HISTORIC AND DESIGN REVIEW COMMISSION

February 19, 2020

HDRC CASE NO: 2020-051
COMMON NAME: 115 BOSTON
ADDRESS: 315 GROVE AVE
LEGAL DESCRIPTION: NCB 2981 BLK 7 LOT 18 ***MASTER FILE//COMMON ELEMENTS***
(THE ROW AT GROVE CONDOMINIUMS)
ZONING: RM-4, H
CITY COUNCIL DIST.: 5
DISTRICT: Dignowity Hill Historic District
APPLICANT: Robert Lee/LindLee,LLC
OWNER: Robert Lee/LindLee,LLC
TYPE OF WORK: Construction of a 1-story, single family residential structure
APPLICATION RECEIVED: January 20, 2020
60-DAY REVIEW: March 20, 2020
CASE MANAGER: Edward Hall
REQUEST:

The applicant is requesting conceptual approval to construct a 1-story, single family residential structure on the vacant lot at 115 Boston Street, located within the Dignowity Hill Historic District. This lot is located at the corner of Boston Street and Lowe Street.

1 CONTEXT-115 BOSTON
 SCALE : N.S.

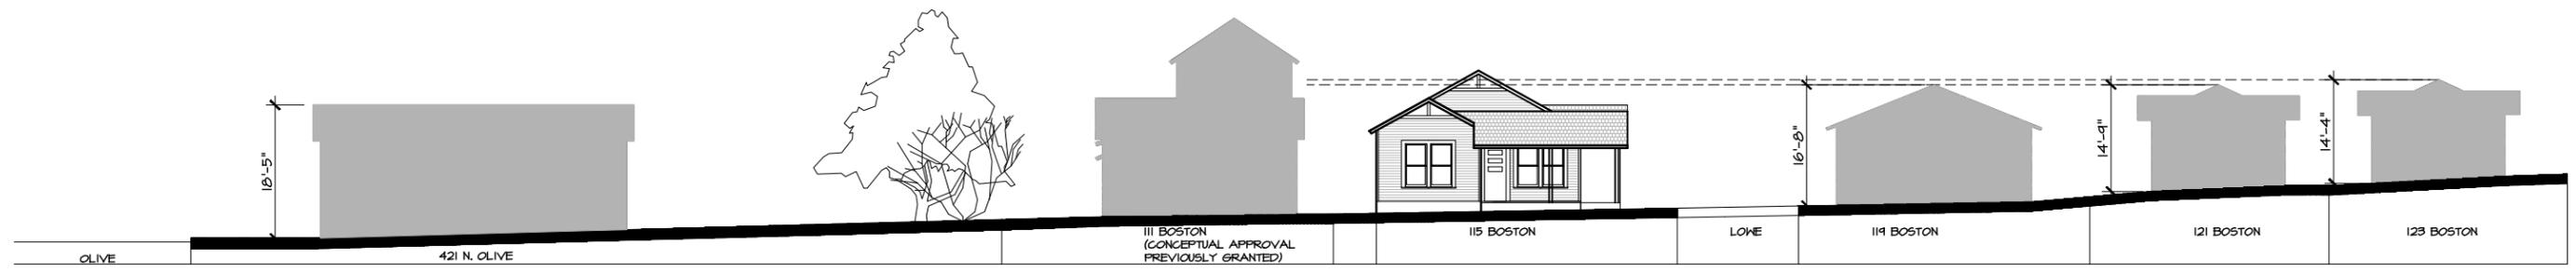
- c. **CONTEXT & DEVELOPMENT PATTERN** – The context and historic development pattern of Boston Street features 1-story, single family residential structures. Recently, the Historic and Design Review Commission has approved new construction featuring 2-story structures.

- d. **SETBACKS & ORIENTATION** – According to the Guidelines for New Construction, the front facades of new buildings are to align with front facades of adjacent buildings where a consistent setback has been established along the street frontage. Additionally, the orientation of new construction should be consistent with the historic examples found on the block. The applicant has not noted the proposed structure’s setback in relationship with those existing on the north side of Boston. Staff finds that a setback diagram should be submitted to staff noting that the proposed new construction features a setback that is greater than those found historically on the block. Regarding the structure’s orientation, the applicant has proposed an orientation that is consistent with those found historically on the block.

- i. That the applicant submit a setback diagram noting that the proposed new construction will feature a setback greater than that of the neighboring historic structure (to the east), as noted in finding d.

1 SOUTH/BOSTON ELEVATION
SCALE: 3/16" = 1'-0"

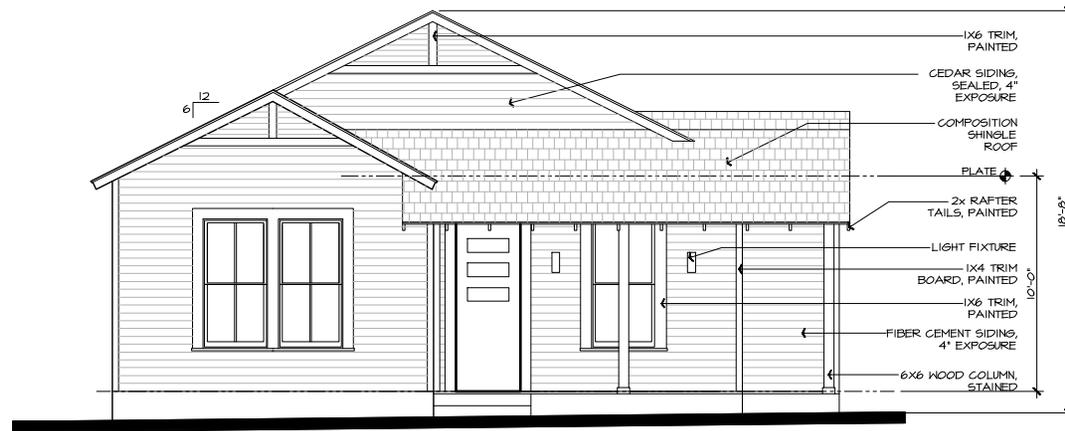
- e. **ENTRANCES** – According the Guidelines for New Construction 1.B.i. primary building entrances should be orientated towards the primary street. The applicant has proposed the primary entrance to front Boston, which is consistent with the Guidelines.

- h. **ROOF FORM** – The applicant has proposed roof forms that include front gables, a hipped roof, and a shed porch roof. Staff finds the proposed roof forms to be appropriate and consistent with the Guidelines.

- l. **FENESTRATION PROFILE** – The applicant has proposed two over two windows, which staff finds to be appropriate and consistent with window profiles found throughout the district. Staff finds that the applicant should incorporate additional window openings toward the front façade on both the east and west elevations, specifically within the porch area.

- vi. That all mechanical equipment be screened from view from the public right of way as noted in finding p.
- vii. That the applicant incorporate additional window openings toward the front façade on both the east and west elevations, specifically within the porch.
